SUNTOP SOLAR FARM

MODIFICATION APPLICATION 1
DEVELOPMENT CONSENT SSD 8696

JULY 2019

The application to modify the development consent involves relocation of the substation and ancillary infrastructure, increased landscaping, a minor administrative change to the Site Plan and modifications to the originally submitted subdivision layout corresponding with the substation relocation.

FIGURE 1 SITE LAYOUT RELOCATED SUBSTATION AND ANCILLARY BUILDINGS

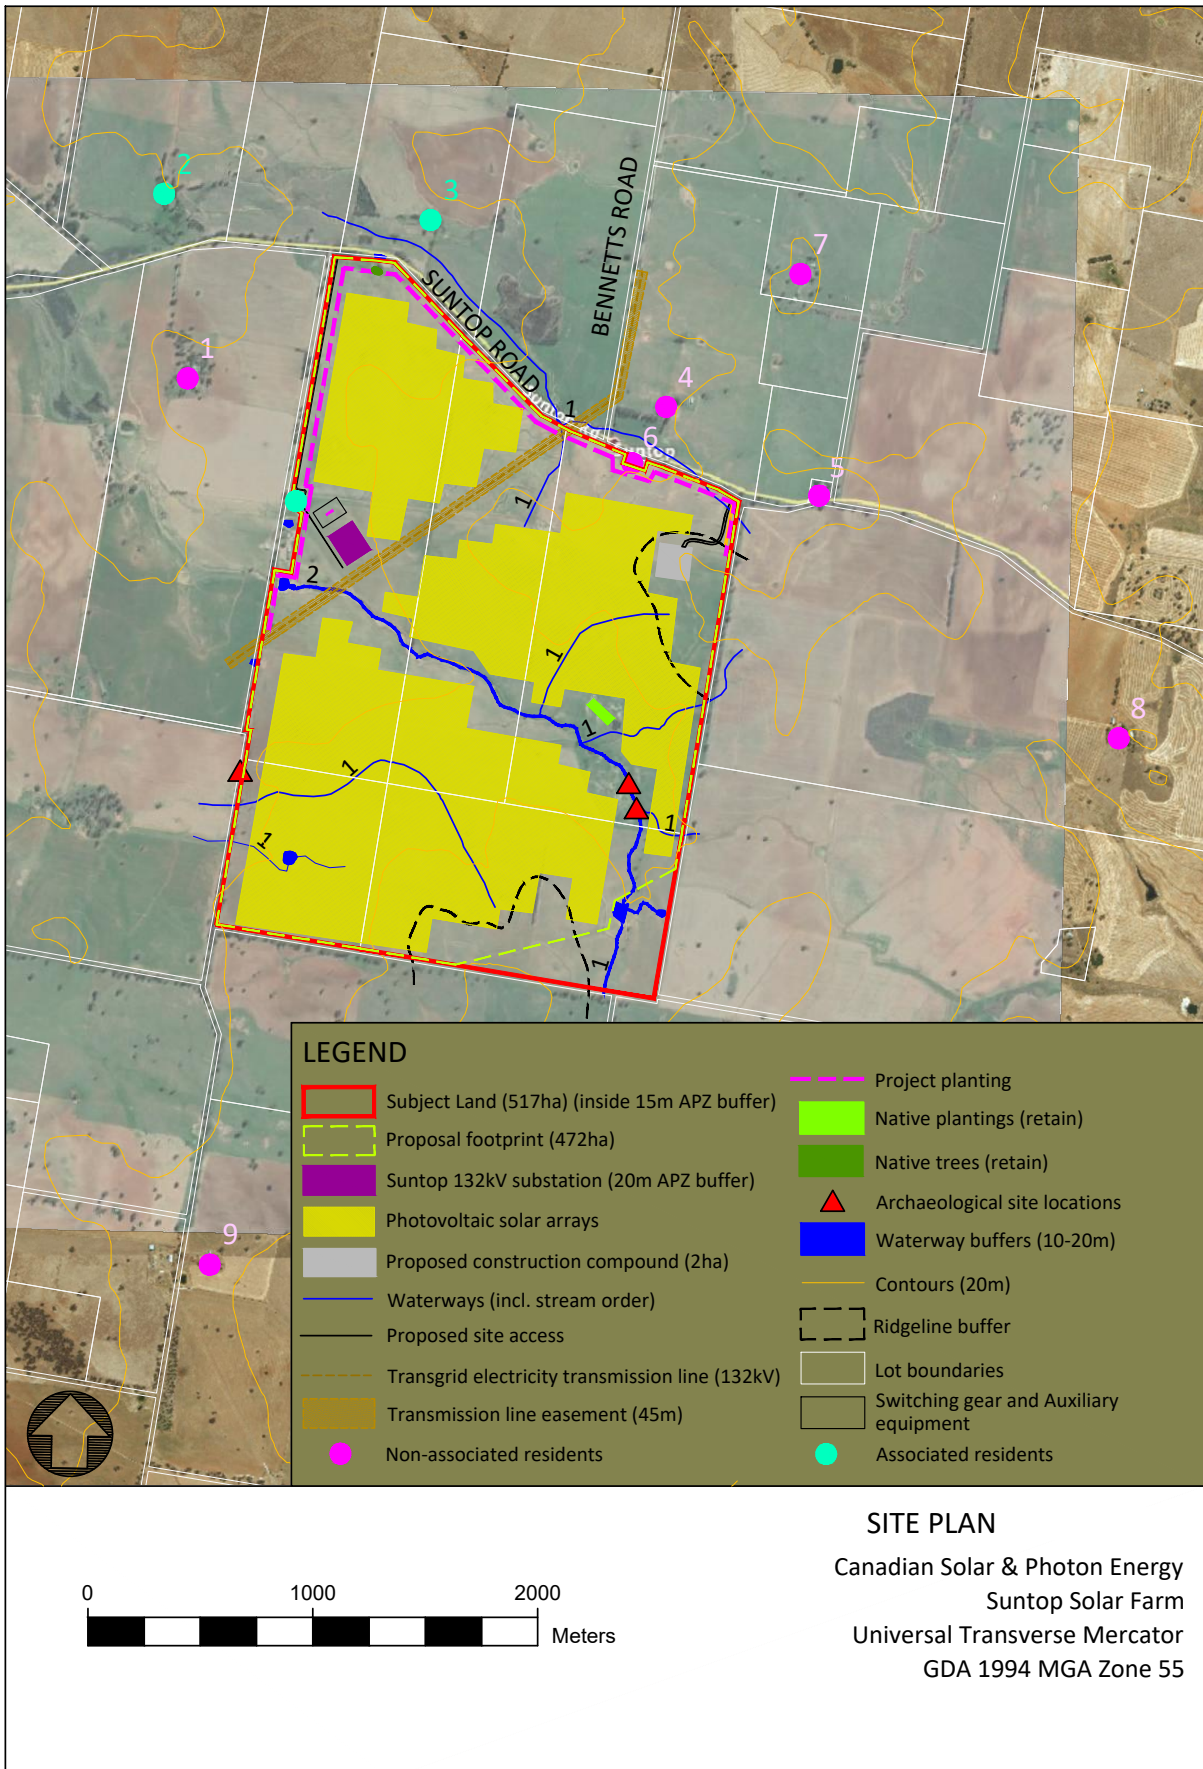
The substation is proposed to be relocated from its approved location and moved approximately 400m to the north east away from the existing waterway as shown below in Figure 1 and attached at Appendix 1. A comparison site plan showing the approved and proposed location of the substation is provided below in Figure 2 below and also attached at Appendix 1.

The modification proposes a minor change to the proposed vegetation screening along the western boundary to increase the screening for the revised substation location. Also shown in Figure 1 above and attached at Appendix 1. It is now proposed to implement a contiguous landscaped screen along the western boundary of the site from the front to the northern edge of the 132kV Powerline easement. Under the approved plan, this planting was infill planting only.

FIGURE 2: SITE LAYOUT PLAN SHOWING COMPARISON OF APPROVED AND PROPOSED SUBSTATION LOCATION

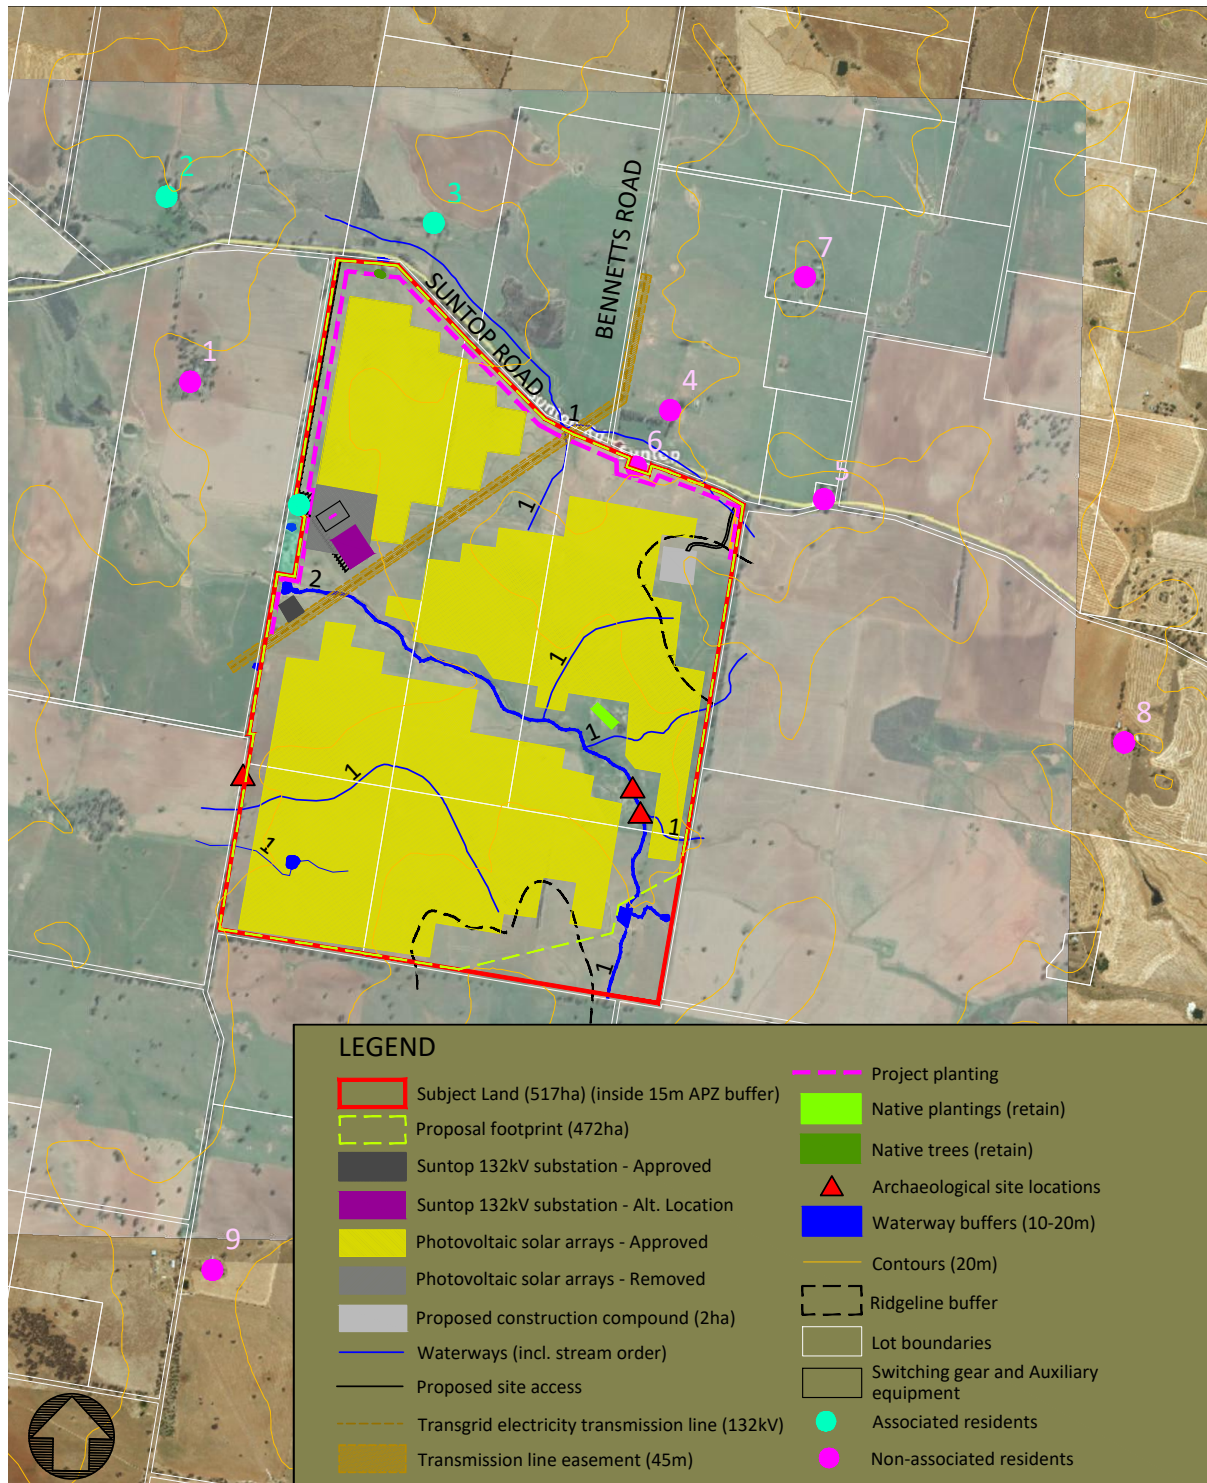
To further assist with understanding the changes associated with the proposed substation relocation, a comparison site plan has been provided at Appendix 1 and comparison plan showing a close up of the substation area is provided at Appendix 2. These plans show the original and proposed position of the substation area for the project to assist in understanding the changes proposed under this modification and their potential impacts. In addition an environmental impact assessment is provided below in Section 5 below.

FIGURE 4: PROPOSED MODIFICATION TO SUBDIVISION RELOCATING LOT FOR THE SUBSTATION AND CREATING AN ACCESS EASEMENT TO THE SUBSTATION (3 LOTS)

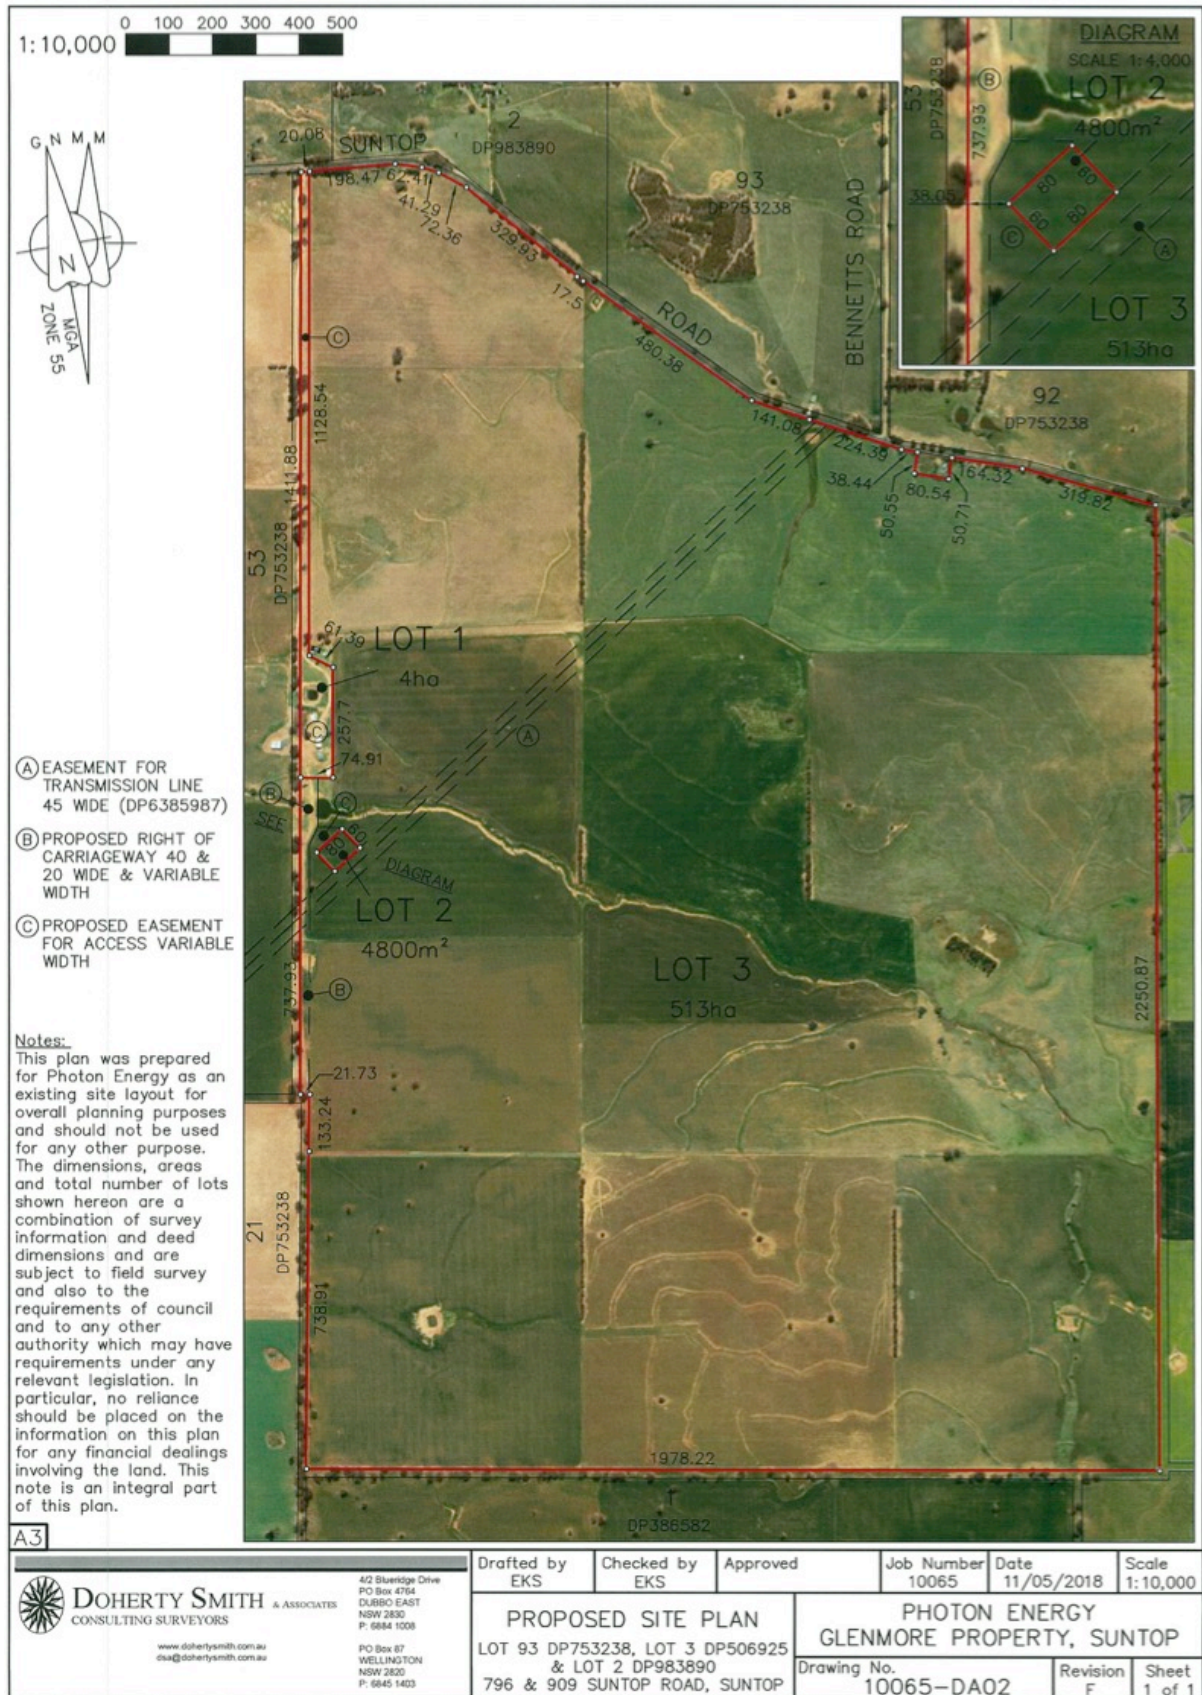
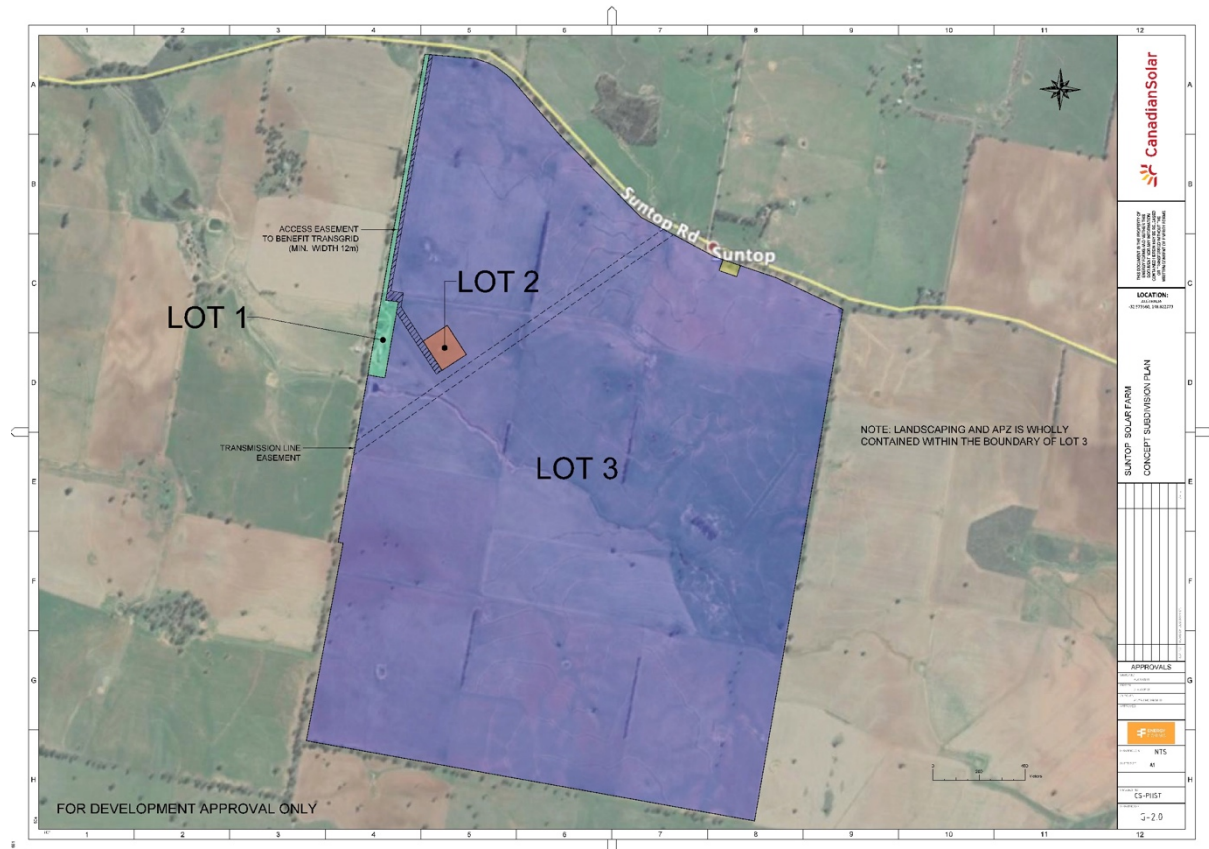
The originally submitted subdivision is shown below in Figure 3 below and attached at Appendix 3 for reference.

Subsequent to the Development Consent, the proposed substation relocation now requires a change to location and dimension of Lot 2 and TransGrid have advised they also require permanent right of access to the substation.

A revised plan of subdivision is shown below in Figure 4 and attached at Appendix 3 for reference. The subdivision is effectively a merging of the existing five lots (Lot 3 DP506925, Lot 122 DP753238, Lot 90 DP657805, Lot 2 DP506925, Lot 1 DP506925) into three lots as per the original Development Consent.

FIGURE 5 COMPARISON OF INDICATIVE LAYOUT FROM ORIGINAL APPROVAL VERSUS PROPOSED LAYOUT FOR MODIFICATION

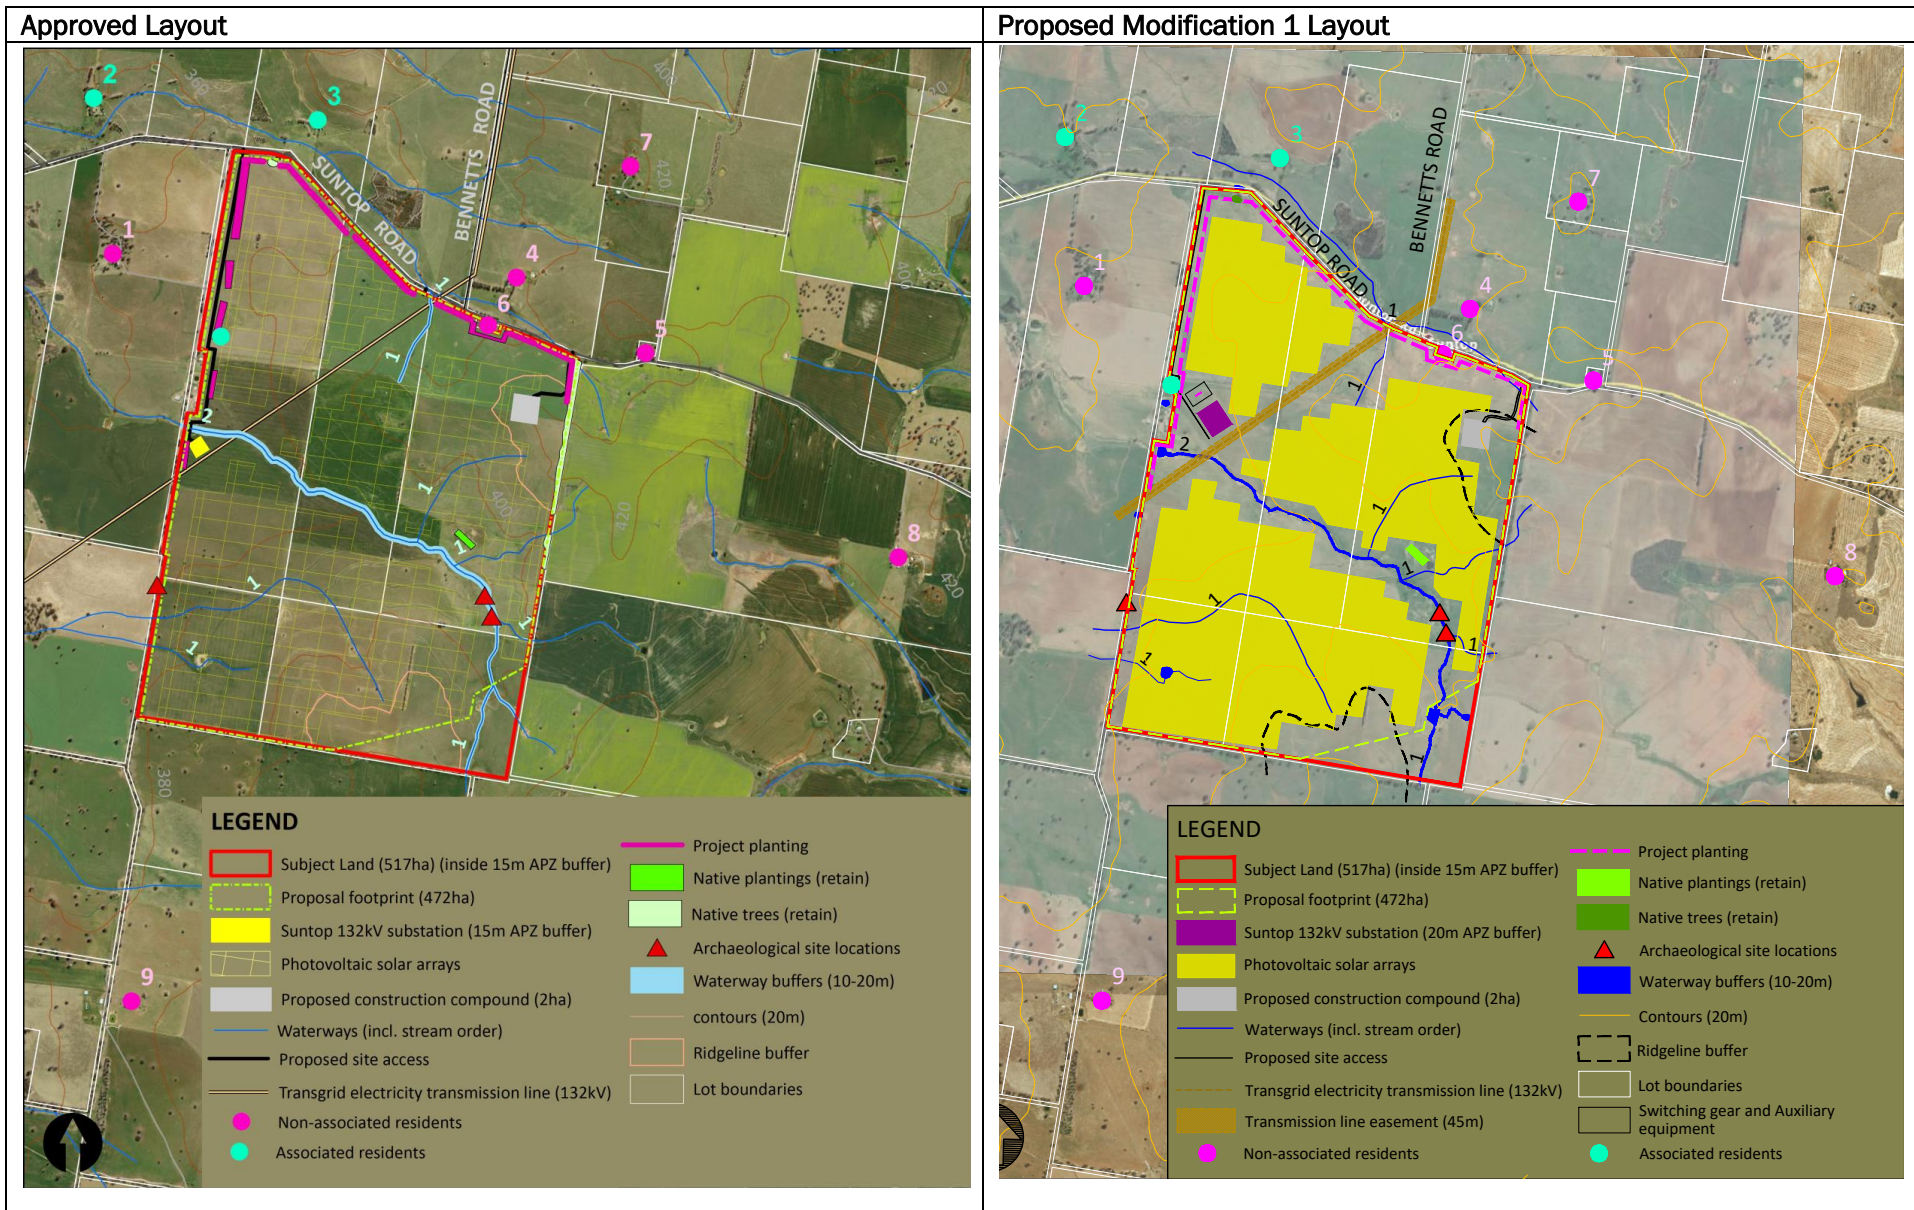
Table 1 below provides a comparative analysis between the approved development and the development in the proposed modification. In addition to the above comparison plan at figure 2, an extract of the site layout and proposed modified layout are provided side by side below at Figure 4 for reference.
